Roads Safety Audit

Intersection of McAuleys Lane and Mullumbimby Road, Myocum

Drawing no.	Rev	Date	Title
10431 SK01	D	17/06/2022	Concept Intersection Layout

Concept Intersection Layout

Intersection Layout
1:500 @ A1

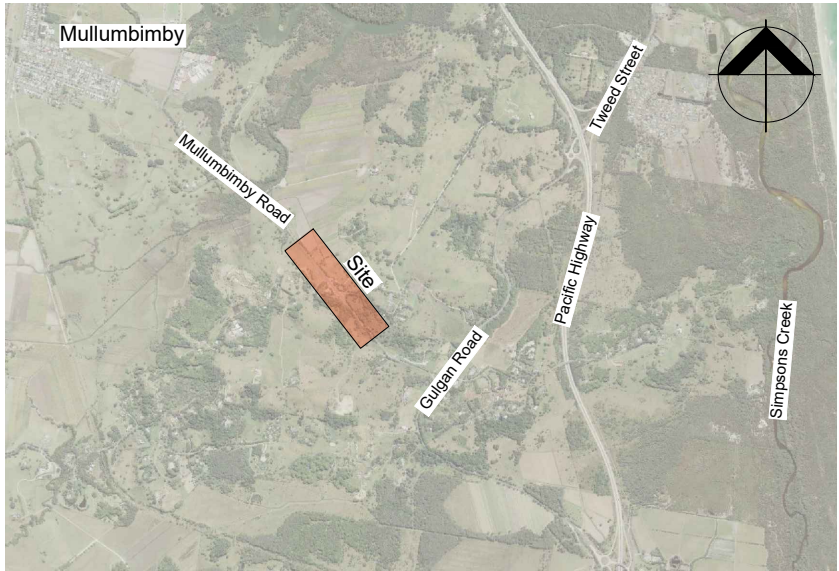
Audit findings	Risk Ranking	Client	
		Accept	Comments
<p>1. Exiting McAuleys Lane</p> <p>Vehicles travelling in the auxiliary left turn lane may prevent motorists exiting the McAuley Lane intersection from seeing northwest bound through traffic.</p> <p>There is a risk that a motorist will proceed through the intersection unaware that there are vehicles travelling towards them in the through-lane at speed on a downhill gradient. This may result in a rear-end or left near collision (e.g. vehicles turning left out of McAuleys Lane) or a right near collision if the vehicle exiting McAuleys Lane was turning right. The latter has the potential to result in a fatal injury given the likely speed of the through traffic. However, the low volumes of traffic utilising the auxiliary left turn lane reduce the expose to this hazard.</p>	<p><i>Rare Fatal</i></p> <p>High</p>	N	There is no accident history as far as we know related to this issue. Left turn in volumes are low. Downgrade in the approach to the left turn would assist in sight distance (seeing over the approaching car). Leave turn lane as is.

<p>2. Crest on Mullumbimby Road between McAuleys Lane and The Saddle Road</p> <p>The proximity of the crest on Mullumbimby Road to the intersection of The Saddle Road and Mullumbimby Road significantly limits the sight distance available for vehicles exiting The Saddle Road. There is a risk that a motorist will proceed through the intersection unaware that there are vehicles approaching from the northwest at speed.</p> <p>This may result in a rear-end or left near collision (e.g. vehicles turning left out of The Saddle Road) or a right near collision if the vehicle exiting The Saddle Road was turning right. The latter has the potential to result in a fatal injury given the likely speed of the through traffic.</p> <p>It is noted, however, that this risk is an existing safety issue and the proposed works do not in any way exacerbate the situation.</p>	<p><i>Possible Serious</i></p> <p>High</p>	N	Noted, but issue not related to McAuleys Lane intersection design.

<p>3. Vegetation at The Saddle Road intersection</p> <p>Vegetation on the eastern side of The Saddle Road intersection limits the sight distance available for vehicles exiting The Saddle Road. There is a risk that a motorist turning right out of The Saddle Road will proceed through the intersection unaware that there are vehicles approaching from the southeast at speed. This may result in a right near collision.</p> <p>It is noted, however, that this risk is an existing safety issue and the proposed works do not in any way exacerbate the situation.</p>	<p><i>Possible Serious</i></p> <p>High</p>	N	Noted, but issue not related to McAuleys Lane intersection design.

Audit findings	Risk Ranking	Client	
		Accept	Comments
4. Bus Stop on Mullumbimby Road <p>The bus stop and shelter on Mullumbimby Road is located shortly after a crest vertical curve.</p> <p>Bus drivers will not be able to see if there are patrons waiting at the bus shelter until the bus is over the crest. There is a risk that a bus travelling northwest will need to break sharply to stop at the shelter. This may result in a rear-end collision involving a vehicle travelling closely the behind the bus at 80 km/h.</p>	<i>Rare Serious</i> Medium	Y	<p>Issue accepted. Will discuss further with Council and bus companies. May not be practical to relocate bus stop</p>

5. Proposed raised island at driveway to No. 110 Mullumbimby Road <p>The proposed raised concrete island appears to be located directly behind the southeast-bound travel lane on Mullumbimby Road. The loss of shoulder space creates a pinch point for cyclists travelling along Mullumbimby Road in a south-easterly direction.</p> <p>There is a risk that a cyclist will abruptly move from the shoulder into the travel lane and be struck by traffic travelling at speed in the same direction.</p>	<i>Unlikely Fatal</i> Extreme	Y	<p>At design stage, island will be designed to allow shoulder users to pass</p>

6. Driveway to No. 110 Mullumbimby Road – Comment Only <p>The site visit revealed significant safety issues associated with the proximity of the crest on Mullumbimby Road to the driveway providing access to No. 110 Mullumbimby Road. Although there is sufficient sight distance available to the right (northwest), the crest severely limits sight distance to the left (southeast).</p> <p>The measures to prevent right turns in or out of this driveway proposed in the concept design remove the exposure to this hazard.</p>	Comment only	-	Noted

7. Proposed G1-207 at driveway to 130 Mullumbimby Road – Comment Only <p>The proposed replacement of the 'Side Road Intersection' sign located approximately 100 m northwest of McAuleys Lane with a larger G1-207 sign may impede sight distance for drivers exiting the driveway.</p> <p>Caution should be taken to ensure this sign is located so as not to adversely impact the sight distance of motorists existing the driveway.</p>	Comment only	Y	<p>At design stage, sign will be located with consideration of sight distance from driveway</p>
